# **Geotechnical Investigation**

## **Proposed Industrial Redevelopment**

135 Cardevco Road  
Carp, Ontario

Report PG6018 -1 Revision 7 dated March 24, 2025

**Figure 2 - Retaining Wall Cross Section Location**

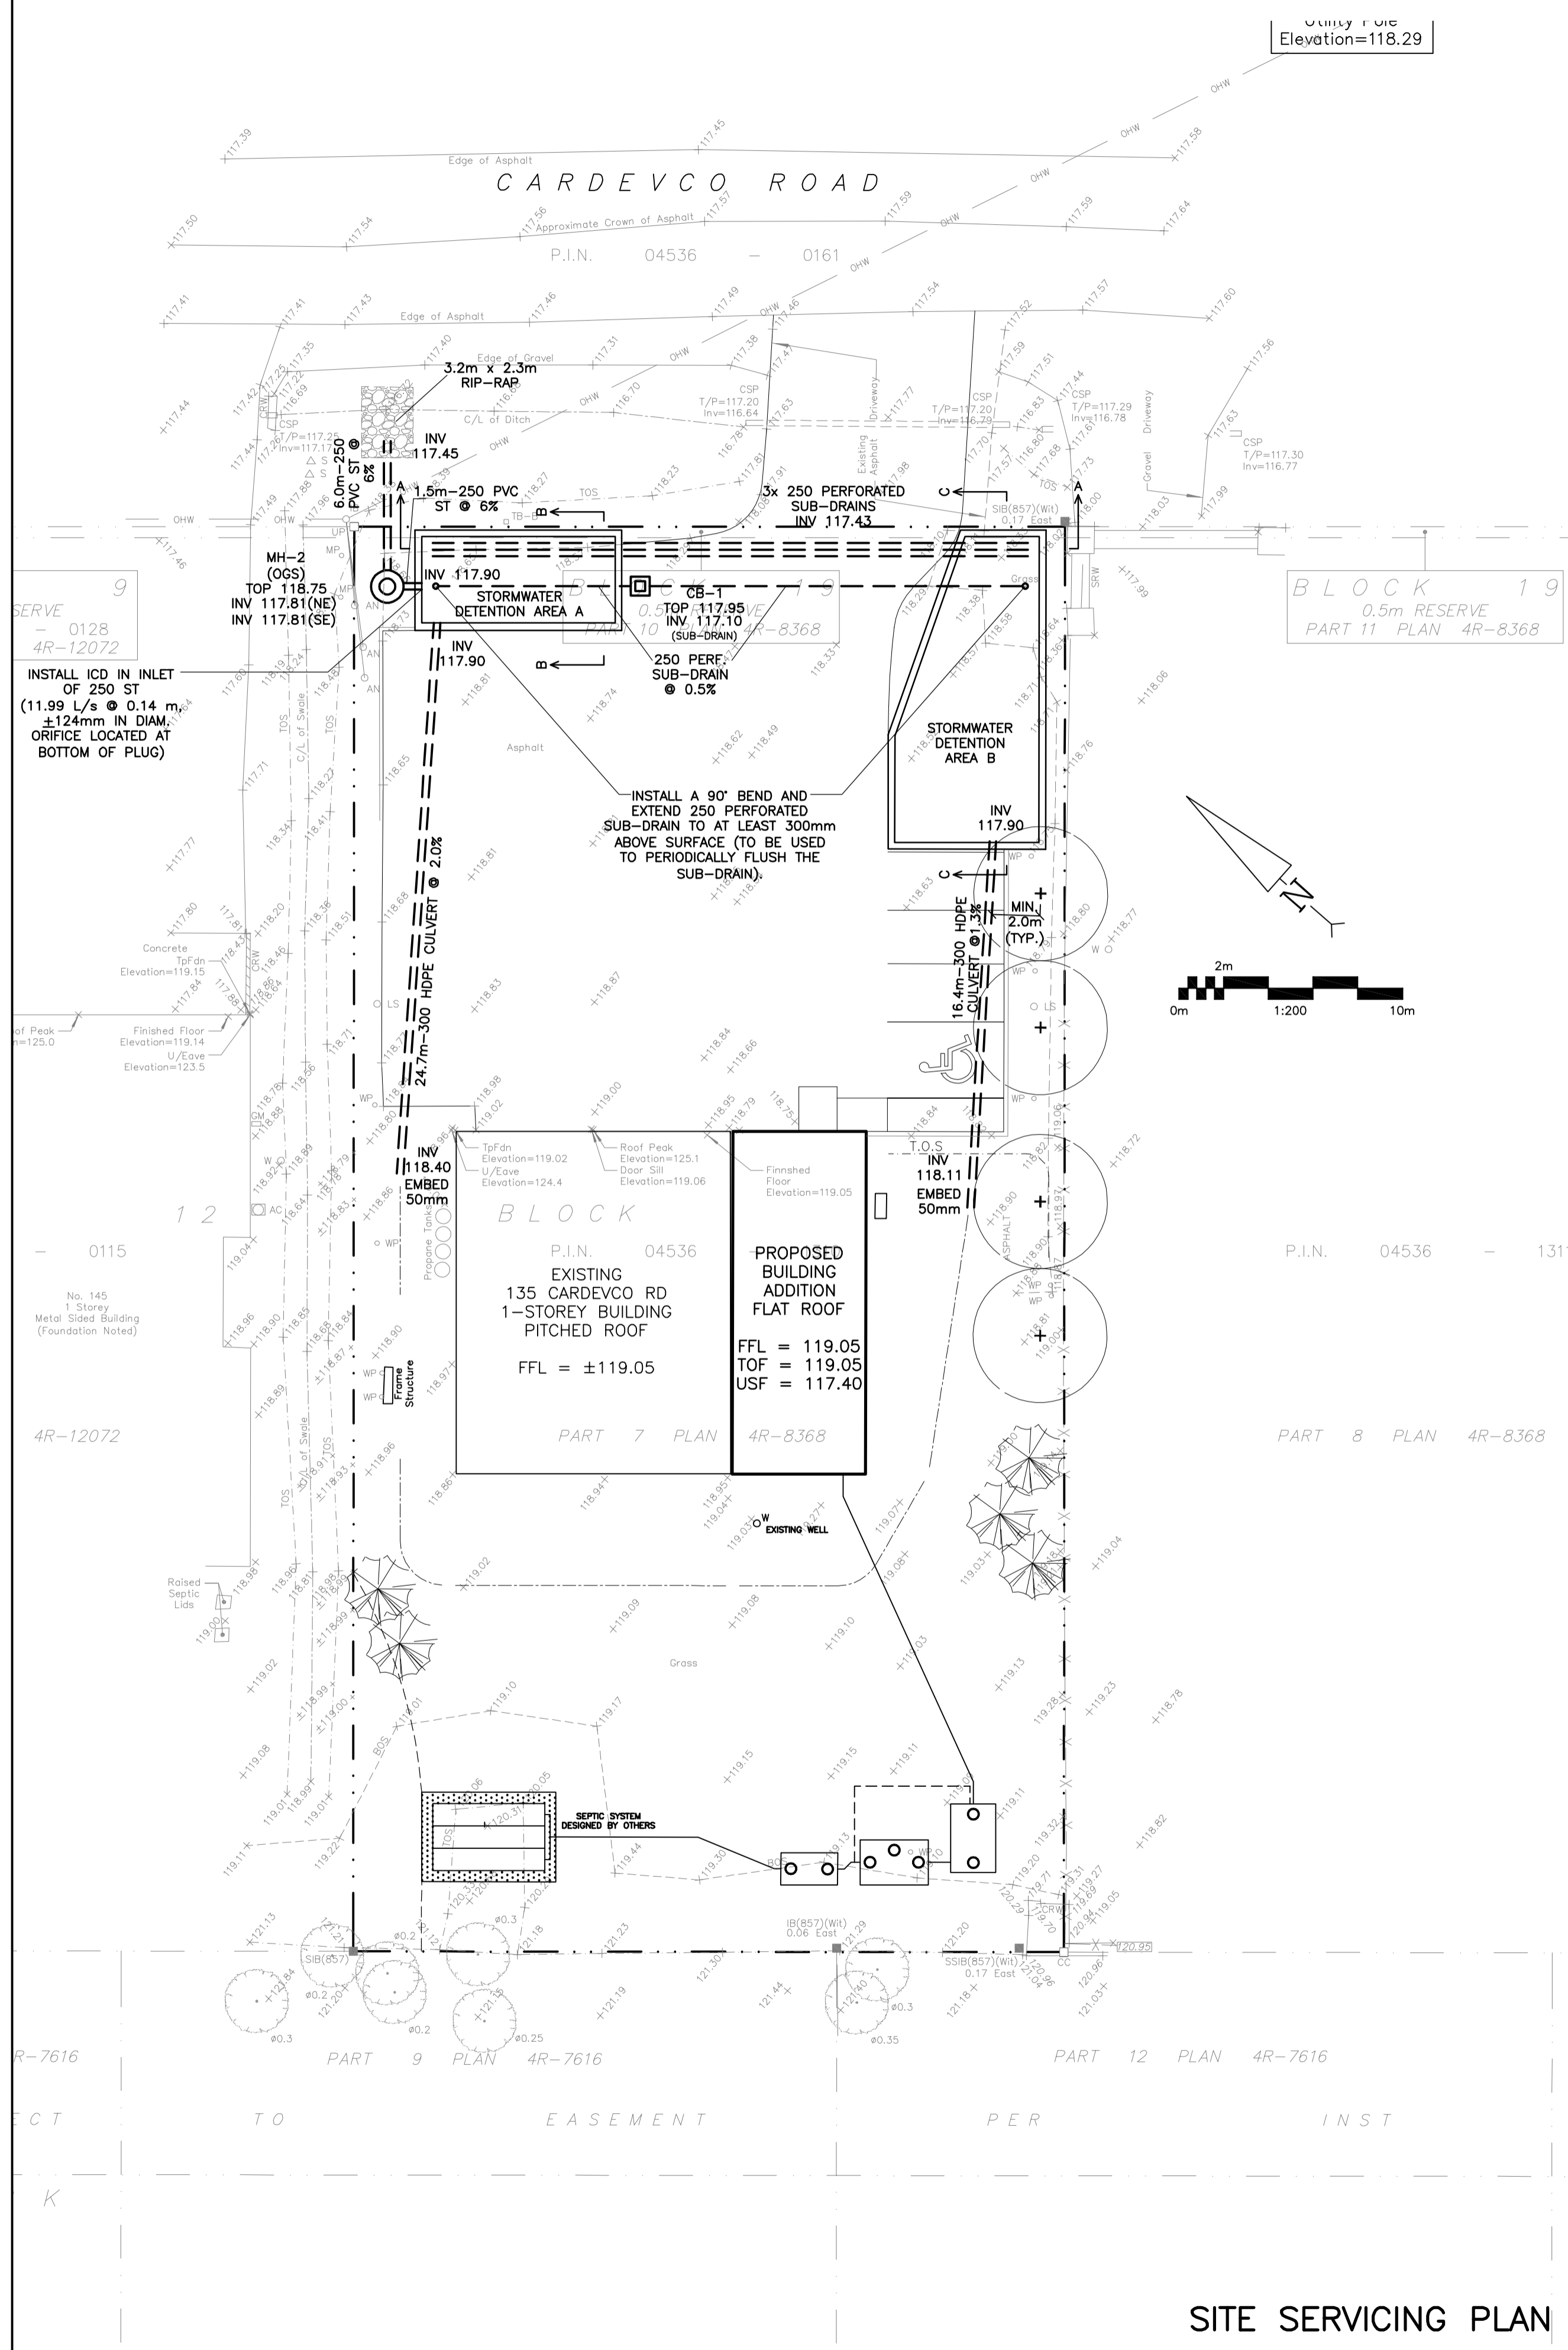
*The response, from D.B.Gray Engineering, to last set of City comments pertaining to the Geotechnical investigation, states that no subdrains are required for the retaining walls. To the contrary, the Section 6.8 Retaining walls (Backfill Material) still references a need for longitudinal drains and weep holes.*

*If no drains are required, please revise the mentioned section and explicitly state in the report that the retaining wall drainage is not required.*

**Comment 10.b:** *Cross-Sections show setback behind the retaining walls between 0.15 m – 0.35 m. Please see the comments above pertaining to the minimum backfill requirement and impacts to the adjacent properties.*

**Response:** Considering the site's groundwater elevation and the proposed footing elevation of the unheated retaining wall structure, the 100 mm diameter drainage pipe (sub-drain) located behind the retaining walls (i.e., along the back of the retaining walls) at the USF elevation of the proposed retaining walls is not required from a geotechnical perspective. Please refer to the updated geotechnical report mentioned above.

**Response:** This comment has been acknowledged. Please refer to the updated geotechnical report mentioned above. Alternative backfill materials have been proposed in cases where there is a limited setback between the proposed retaining wall and the property line.

**UNDERPINNING PROGRAM  
DETAIL**

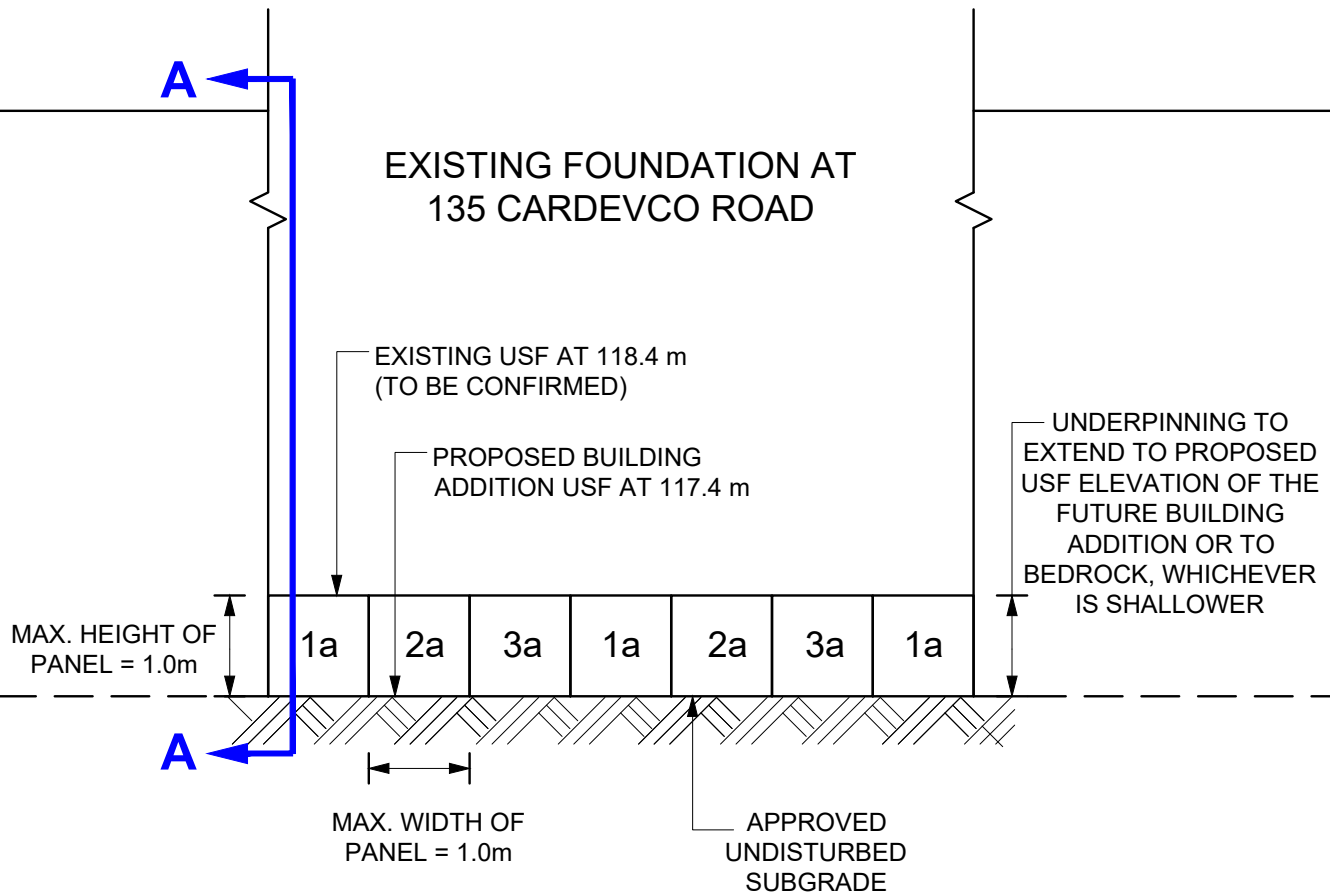
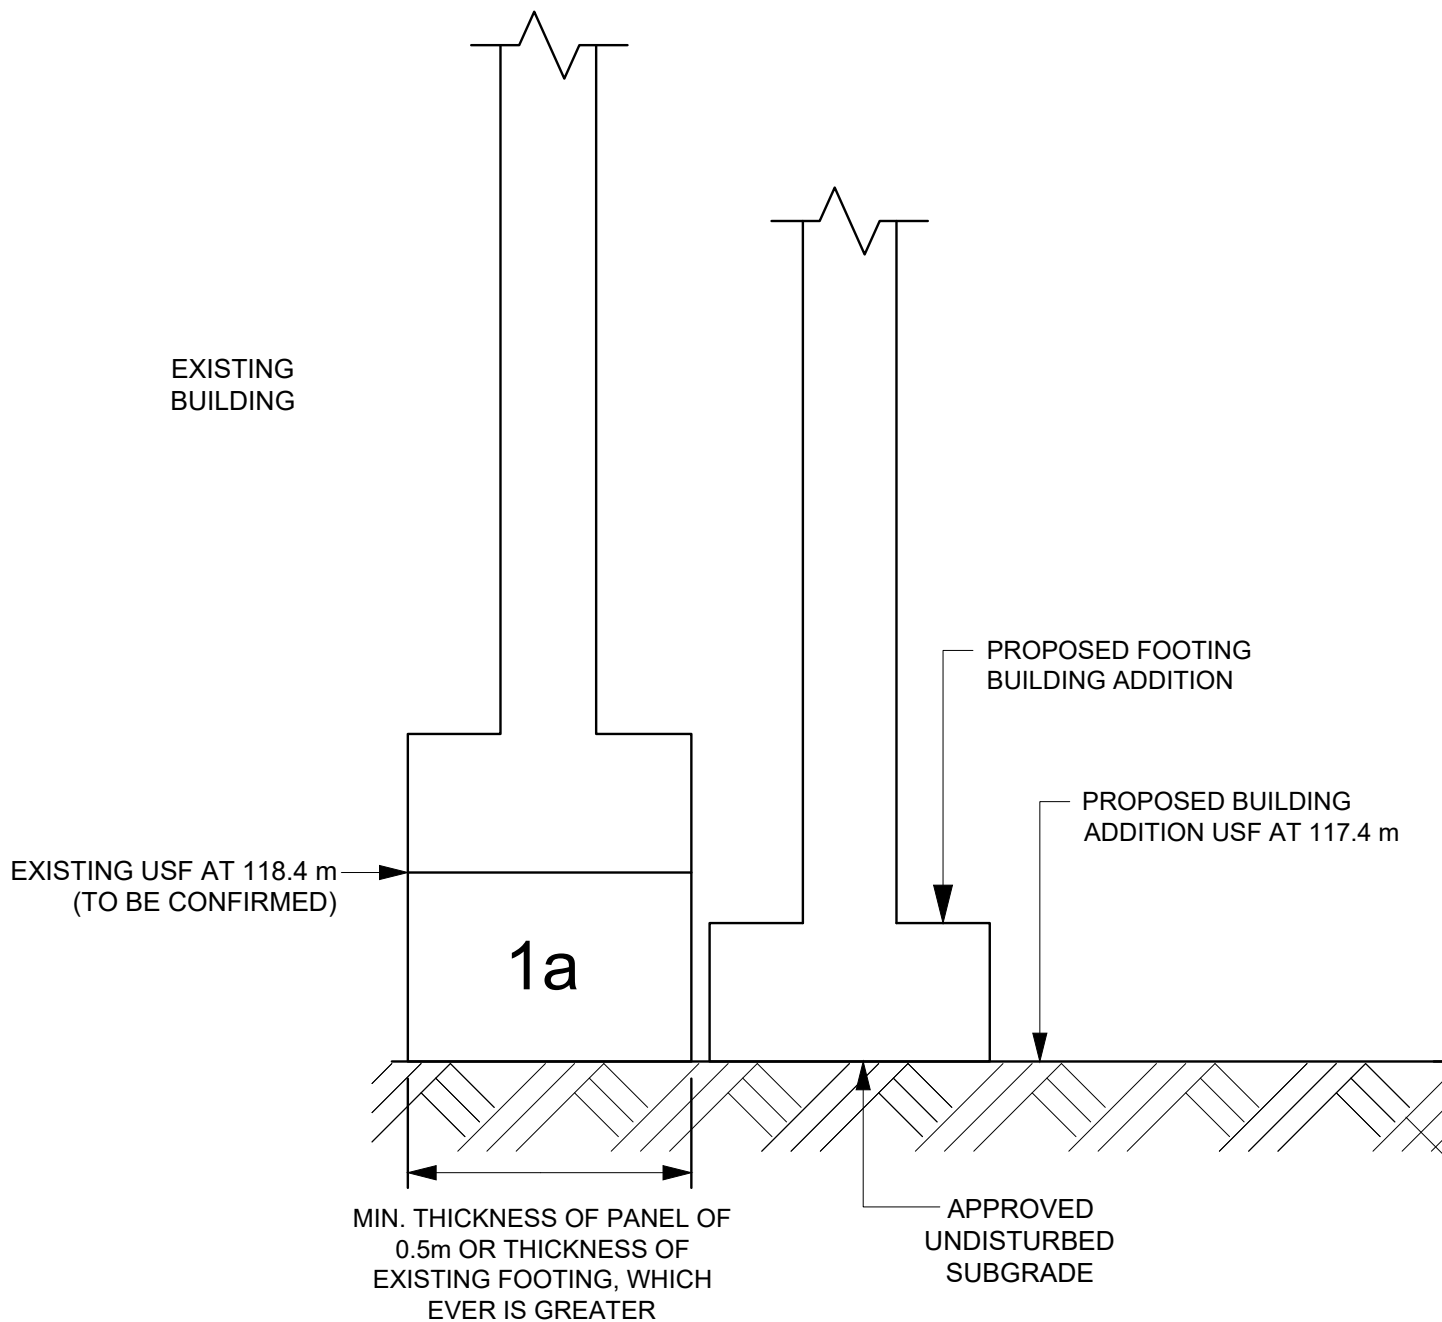
Based on our review of the grading plans, and on information collected from our geotechnical investigation, it is understood that the USF for the proposed building addition and the eastern foundation wall are at approximate geodetic elevation of 117.40 and 118.40 m, respectively. Furthermore, there will be no horizontal setback between the proposed building addition and the eastern foundation wall of the existing warehouse. Therefore, the underpinning of the eastern foundation wall of the existing warehouse should be underpinned.
